DEPARTMENT OF NATURAL RESOURCES Division of Water Rights

DAM INSPECTION REPORT - 2023

Dam Name / Number	Silver Leaf / UT00327								
Inspection Date	May 2, 2023 Hazard rating High								
Weather	Cloudy, Mid 60°'s	Rating is appropriate?	Yes						
Reservoir Level, ft	4,998.1	SOP is current?*	Yes						
Date of last outlet insp.	2017	EAP is current?*	No						
Spillway Flow, cfs	None	EAP is distributed?*	No

Photo #2:

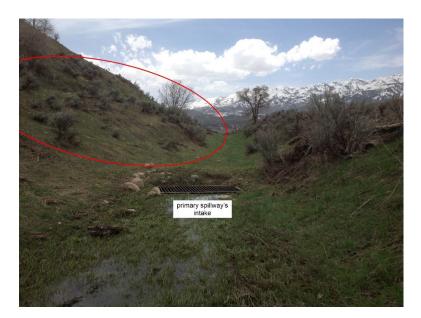
Checklist Item	Necessary Action, Maintenance and/or Repair:			
1.2	Continue efforts to eradicate rodent activities from the dam embankment and			
1, 2	completely backfill their burrows.			
	Continue efforts to remove woody vegetation from and within 25-feet of the			
2, 3, 4, 6, 8 dam embankment. Particularly on the upstream slope and in the right				
	downstream toe and abutment groin area.			
	a) The staff gage is unreadable. Re-mark the concrete pedestal elevation			
23	plates according to the 2019 survey.			
	b) We support plans to install a new sloping staff gage.

Caption: Willows becoming established on the upstream slope.
